Well Name: CORRAL 23-35 FED COM	Well Location: T25S / R29E / SEC 23 / NWNW / 32.12172 / -103.963056	County or Parish/State: EDDY / NM
Well Number: 101H	Type of Well: OIL WELL	Allottee or Tribe Name:
Lease Number: NMNM120895	Unit or CA Name:	Unit or CA Number:
US Well Number: 3001556885	Operator: XTO ENERGY INCORPORATED

Sundry ID: 2862090

Type of Submission: Notice of Intent	Type of Action: APD Change
Date Sundry Submitted: 07/08/2025	Time Sundry Submitted: 02:28
Date proposed operation will begin: 07/15/2025

Procedure Description: XTO Energy Inc. respectfully requests approval to make the following changes to the approved APD. Changes include KOP, FTP, LTP, BHL Proposed total depth, pool, and dedicated acreage, Formation, Casing Design, Cement Program & Mud Circulation System. APD ID 10400098911; Well API: 30-015-56885 FROM: TO: KOP: 382' FNL & 209' FWL OF SECTION 23-T25S-R29E 330' FNL & 495' FWL OF SECTION 23-T25S-R29E FTP: 100' FNL & 540' FWL OF SECTION 23-T25S-R29E 330' FNL & 495' FWL OF SECTION 23-T25S-R29E LTP: 100' FSL & 540' FWL OF SECTION 35-T25S-R29E 330' FSL & 495' FWL OF SECTION 35-T25S-R29E BHL: 50' FSL & 540' FWL OF SECTION 35-T25S-R29E 50' FSL & 495' FWL OF SECTION

OFFLINE CEMENTING

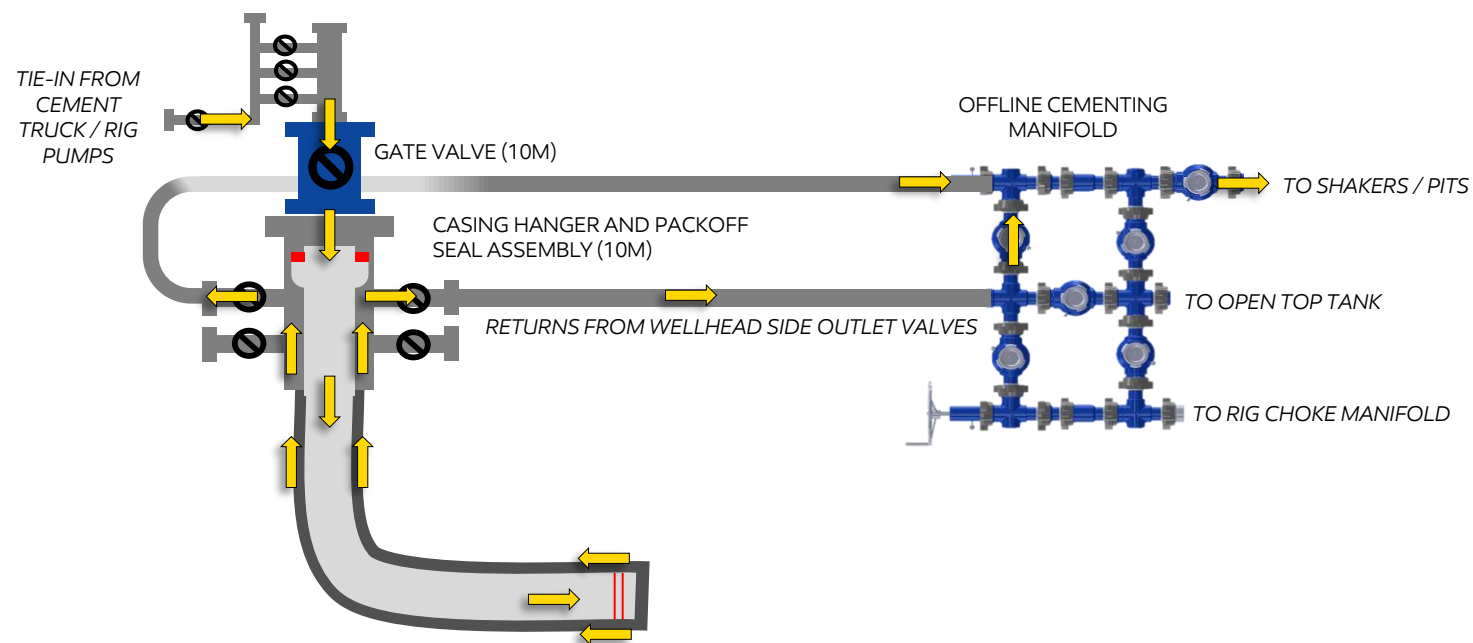
1. Rig BOP replaced by gate valve and WH adaptor assembly (10M rated)
2. Addition of offline cementing manifold and high pressure iron to direct fluid returns to rig active system and/or choke manifold
3. Packoff annulus barrier in place and tested prior to cementing operations (10M rated)
4. Cement truck performs cement job displacement (vs rig pumps)
